### APPEAL SUMMARY

<b>Appeal ID:</b> 21954	<b>Project Address:</b> 151 SW 1st Ave
<b>Hearing Date:</b> 10/2/19	<b>Appellant Name:</b> Tom Jaleski
<b>Case No.:</b> B-015	<b>Appellant Phone:</b> 9712385266
<b>Appeal Type:</b> Building	<b>Plans Examiner/Inspector:</b> John Cooley
<b>Project Type:</b> commercial	<b>Stories:</b> 5 <b>Occupancy:</b> B, M, S-1 <b>Construction Type:</b> III-A
<b>Building/Business Name:</b> PAE Living Building	<b>Fire Sprinklers:</b> Yes - Throughout
<b>Appeal Involves:</b> Erection of a new structure, Reconsideration of appeal	<b>LUR or Permit Application No.:</b> 19-124284-LU
<b>Plan Submitted Option:</b> pdf [File 1] [File 2] [File 3] [File 4]	<b>Proposed use:</b> Office, Retail

# PAE Living Building

## Engineering Judgment Report #1

1 **PLAN DETAIL - PILASTER AT LEVEL 5 RECESS**  
EX3-G 1 1/2" = 1'-0"

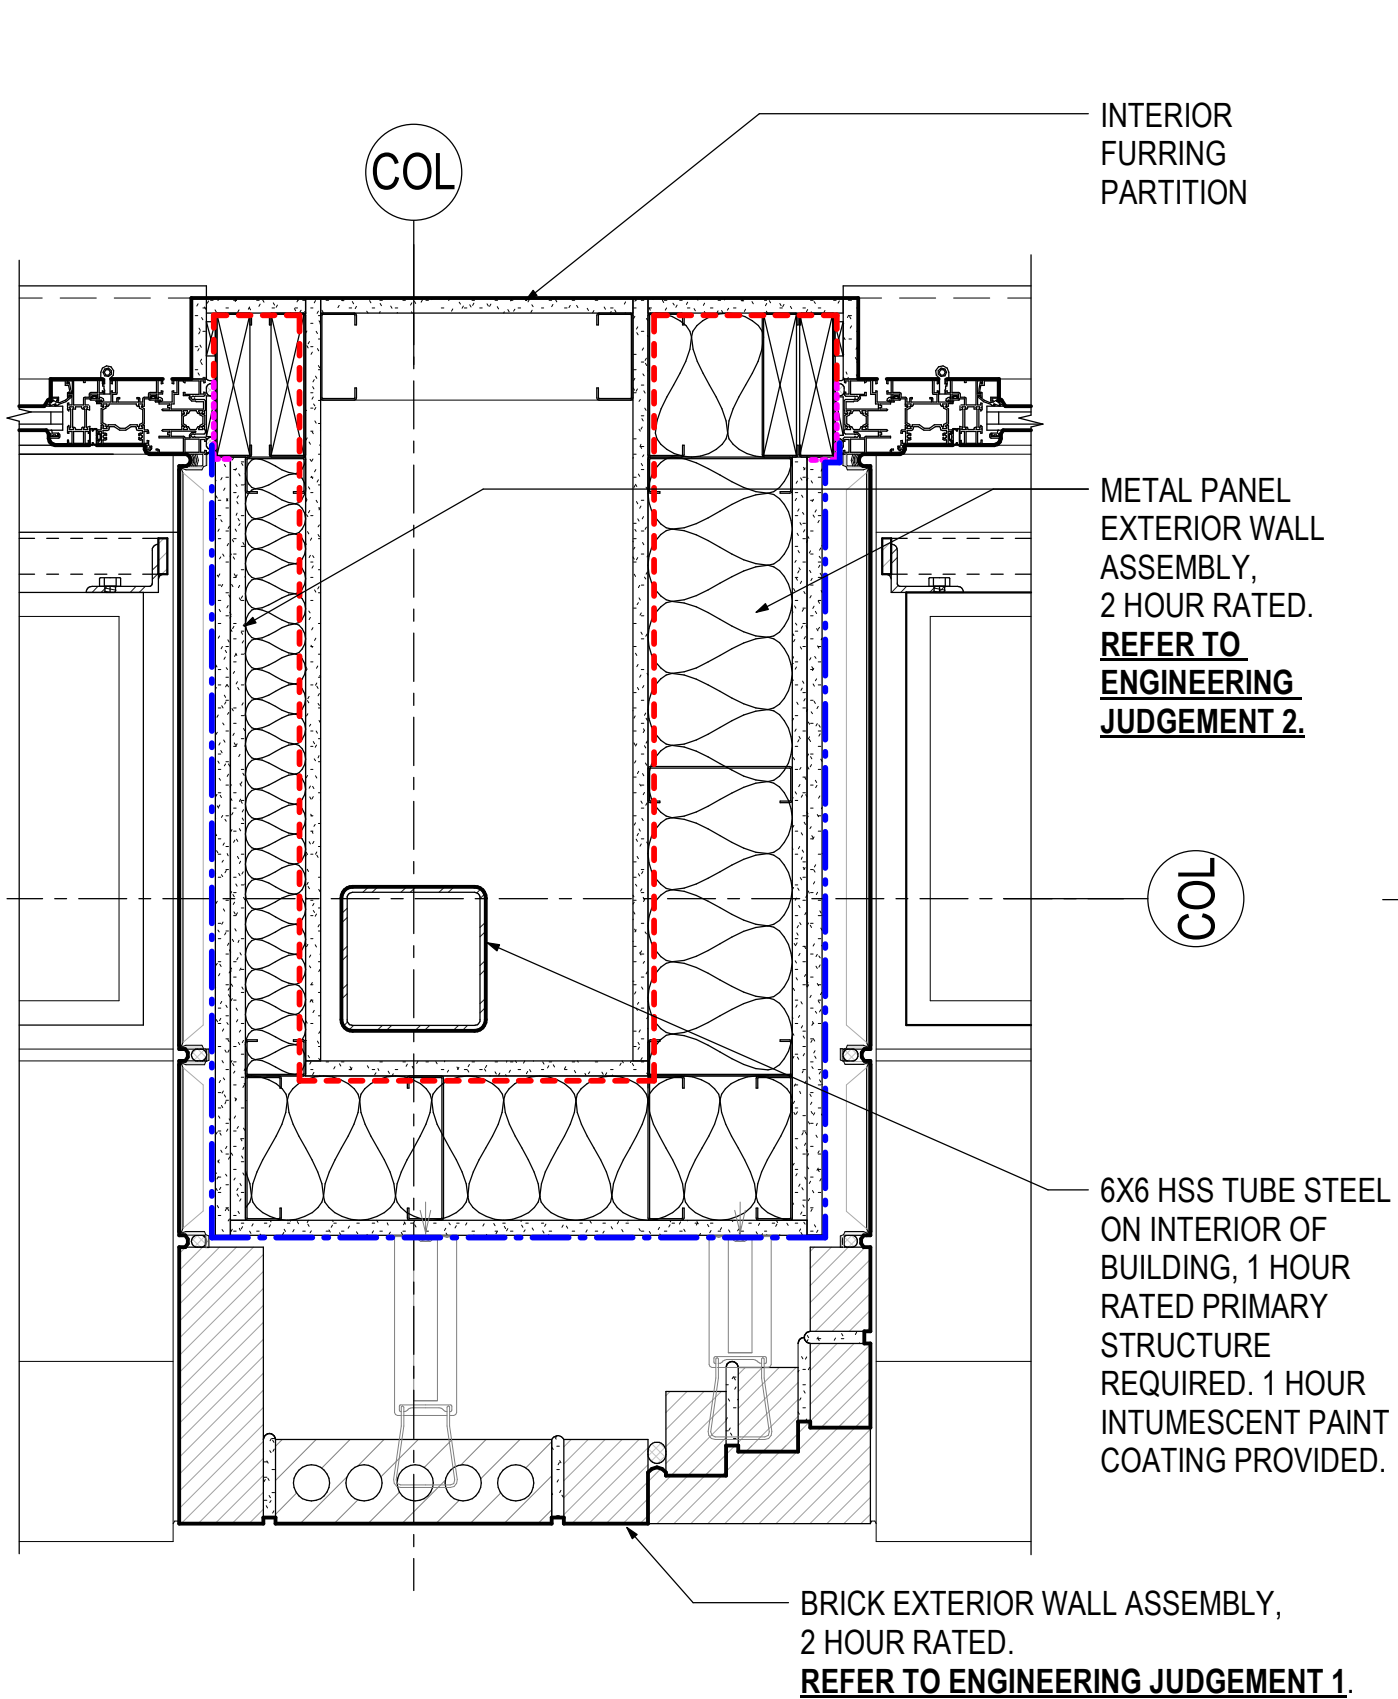
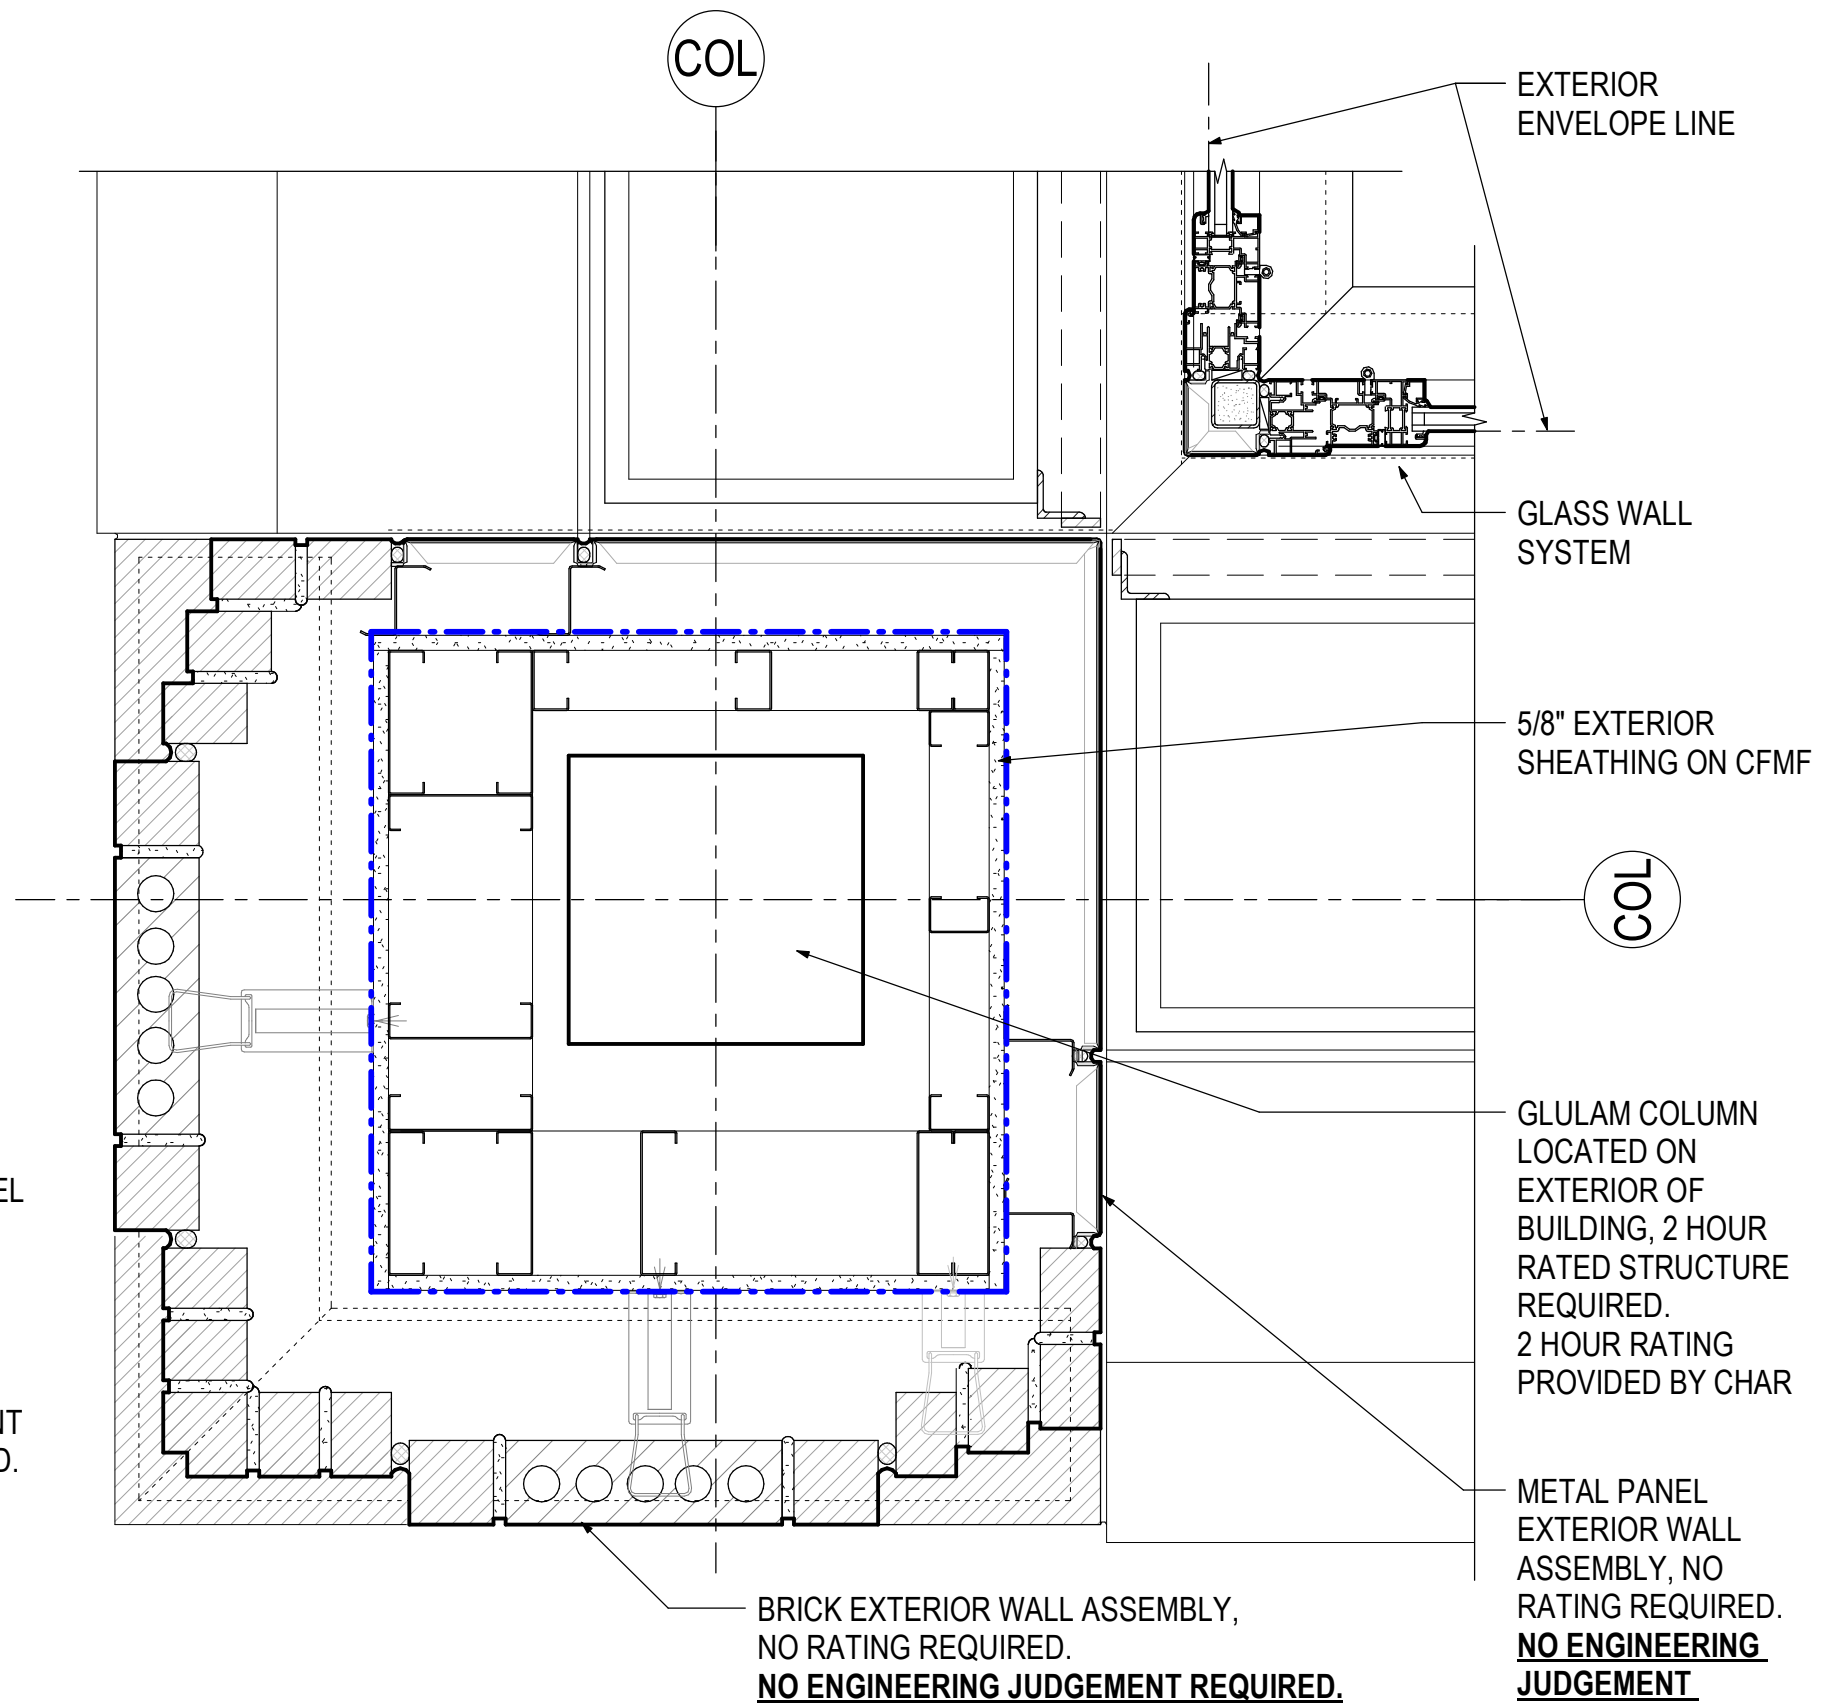
On levels 1 and 5 on the South and East exterior walls, there are recesses between the column bays. In those locations the structure is still completely on the inside of the inner most exterior wall layer, and per Table 601 will require 1-hour rating. The exterior wall assemblies on all sides of the columns and beams will be designed to provide a 2-hour protective rating from the exterior side, this will protect the primary structure from any fire risk on the exterior of the building. These locations only occur on the street facing walls with a fire separation distance of greater than 30', additionally the locations on the 5th floor are over 56' above grade level.

### **Alternate 2 hour wall assemblies with engineering analysis: Granted as proposed.**
